**ZONING AMENDMENT,
PLANNED UNIT DEVELOPMENT &
SUBDIVISION STAFF REPORT**

Date: February 3, 2011

Overlook Road VOA Housing Subdivision

6917 Overlook Road
(South side of Overlook Road, 625'± East of Cody Road)

SITE PLAN

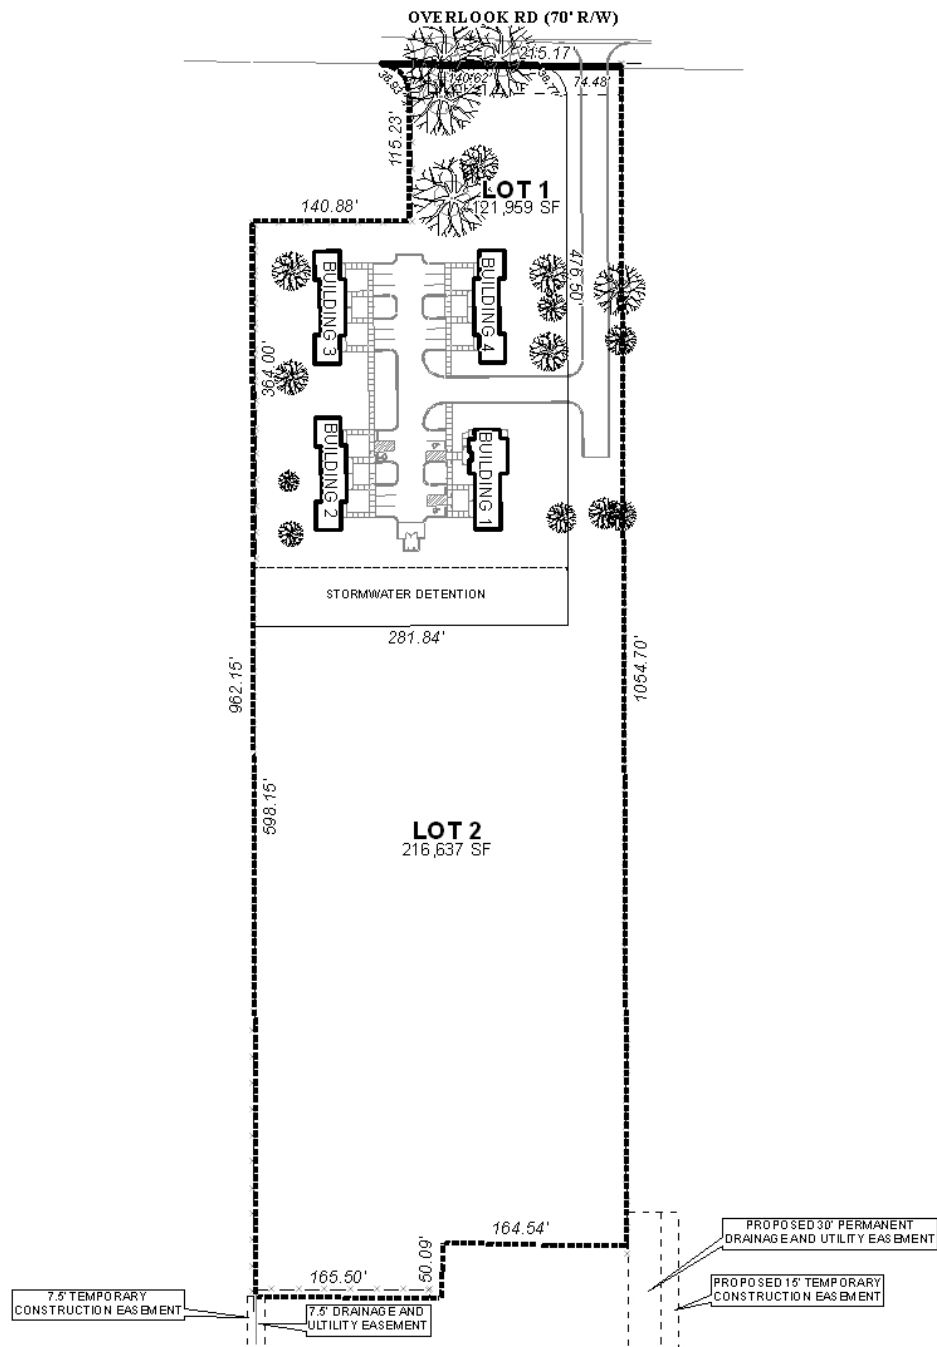
The site plan for the Planned Unit Development should be revised to identify the stormwater detention area as identified on the subdivision plat. The landscaping plan for the site is

accurate, but the frontage trees should be revised to allocate trees according to individual frontages of Overlook Road and the proposed access street and not the site as a whole.

The site plan should be revised to indicate the provision of a 6' wooden privacy fence where the site adjoins residential properties. Lighting for the site should be so arranged that the source of light does not shine directly into adjacent residential properties or into traffic, as per Section 64-6.A.3.c. of the Zoning Ordinance.

- 1) completion of the subdivision process;*
- 2) revision of the site plan to identify the stormwater detention area as in the subdivision plat;*
- 3) revision of the tree planting plan to allocate frontage trees according to individual road frontages and not the site as a whole;*

- 4) revision of the site plan to provide a 6' wooden privacy fence where the site adjoins residential properties;*
- 5) revision of the site plan to depict the 25' setback line along Overlook Road and along the proposed access street;*

- 6) lighting for the site is to be so arranged that the source of light does not shine directly into adjacent residential properties or into traffic, as per Section 64-6.A.3.c. of the Zoning Ordinance;*

- 7) the site is limited to one shared driveway and curb cut, with the size, location and design to be approved by Traffic Engineering and conform to AASHTO standards;*
